# CITY OF PORTLAND, MAINE

## HISTORIC PRESERVATION BOARD

#### HISTORIC PRESERVATION BOARD MEETING

**TO:** Chair Pollard and Members of the Historic Preservation Board  
**FROM:** Rob Wiener, Preservation Compliance Coordinator  
**DATE:** October 2, 2020  
**RE:** October 7, 2020 **Public Hearing** – Exterior Alterations, Wharf Street Level

1 | CENTER ST. FACADE EXISTING / DEMO  
1/4" = 1'-0"

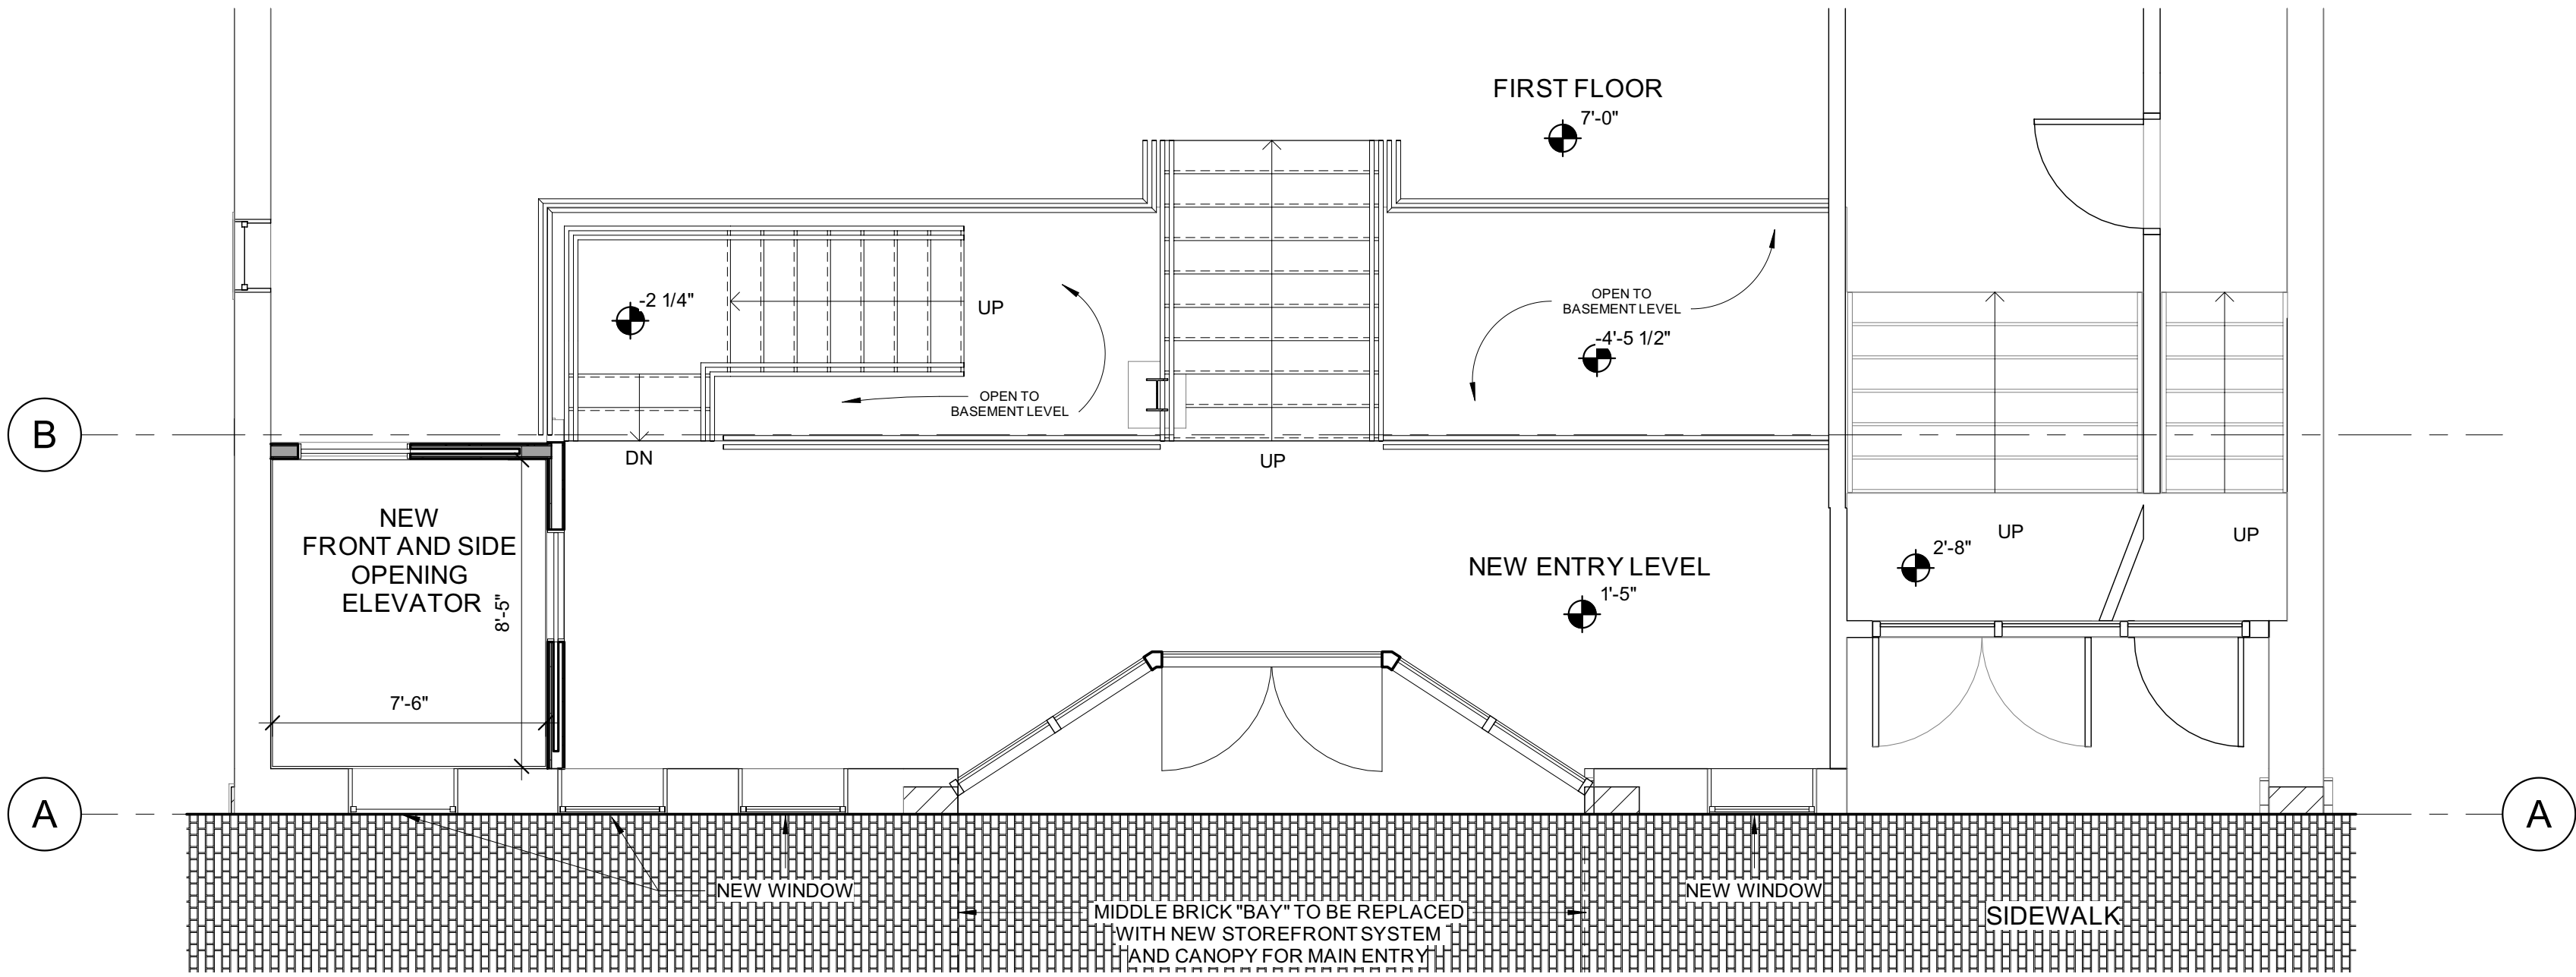
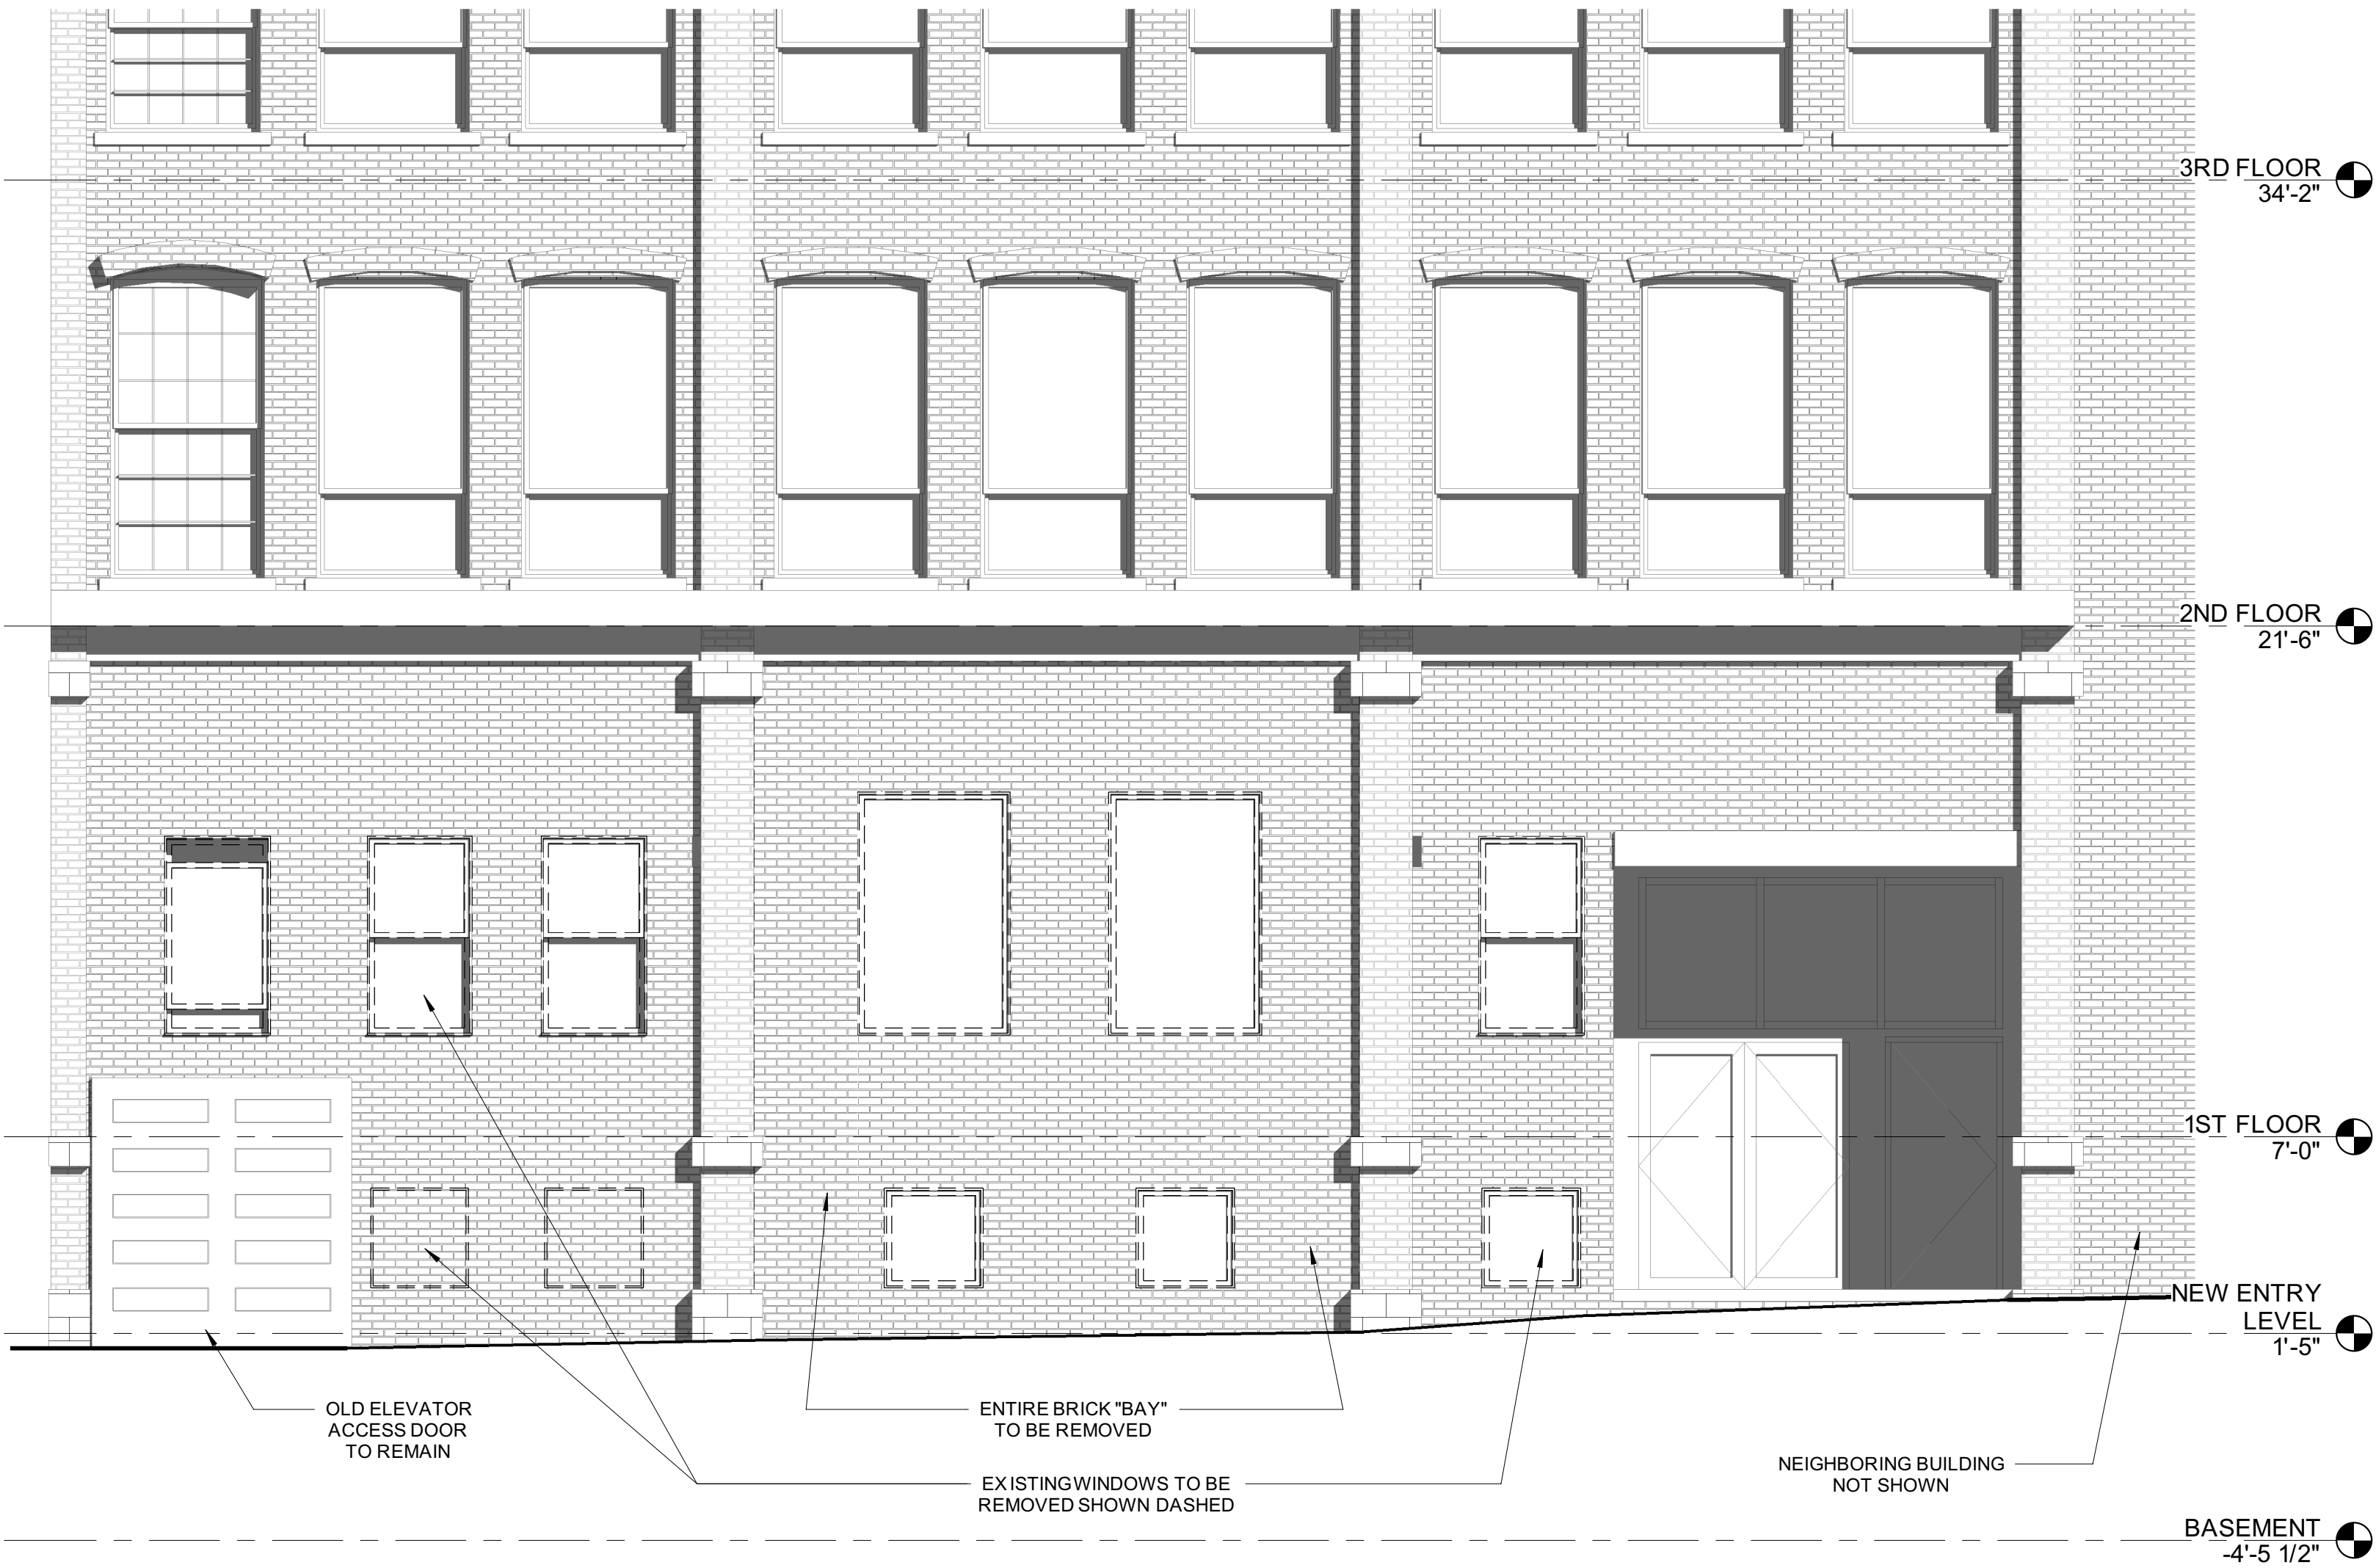
- Design details for the canopy have not been provided, but see description above. The Board will want to determine whether they want to see the details or leave final review to staff. There may be signage atop the canopy, according to the architect.
- The color of the existing upper storefront entry is bronze, as are upper floor windows. Proposed storefront components and windows are described by Mr. Broadbent as being dark – black or dark grey, to align with existing windows.
- Staff is unfamiliar with the age of the upper entrance. Is any work planned there in

- the next several years? Mr. Broadbent has asked the owners, but has not heard.
- What surface is proposed for the threshold at the recessed entrance alcove?
  - Some engineering is often required with a sloping sidewalk, and a new or renovated entrance. Staff hopes that concerns for ADA compliance, including sidewalk leveling or adjustment of the cross slope will not seriously impact the design.
  - There is an existing Fire Department Connection in the brick infill to be removed. Staff hopes a suitable substitute location has been found.
  - In response to staff's question Mr. Broadbent said exterior lighting is going to be recessed in the proposed canopy ceiling.
